Re: **Hotchkiss School Dining Facility Renovations**

We are in receipt of Engineering Review Comments dated November 20, 2023. We offer the following responses, with the initial comments repeated and our responses in bold face type.

## Sheet C4-02

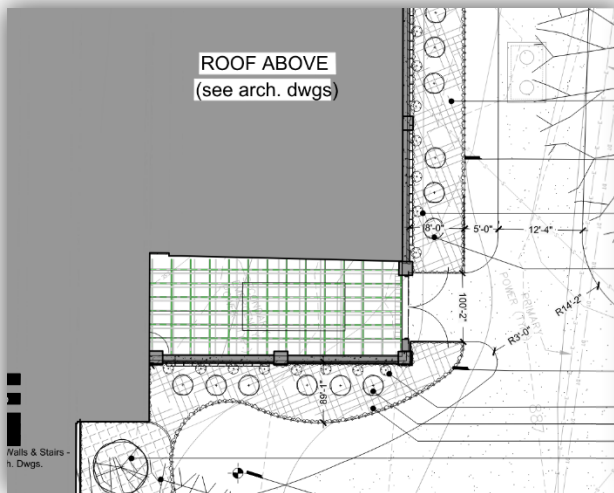
2. Provide Emergency Contact name and 24-hr. emergency contact telephone number for Responsible Party.

**Emergency contact information has been added to drawing C4-02.**

## Sheets L100 & L102

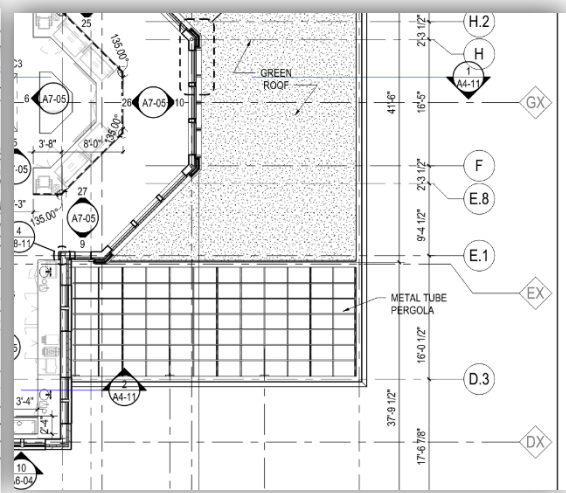
1. Clarify hatching in the loading dock and adjacent areas. Note: the hatch as shown does not appear in the Symbol Legend.

**The unidentified hatched area is a metal tube pergola, as depicted on architectural drawing A3-02.**

**From L102:**

**From A3-02:**
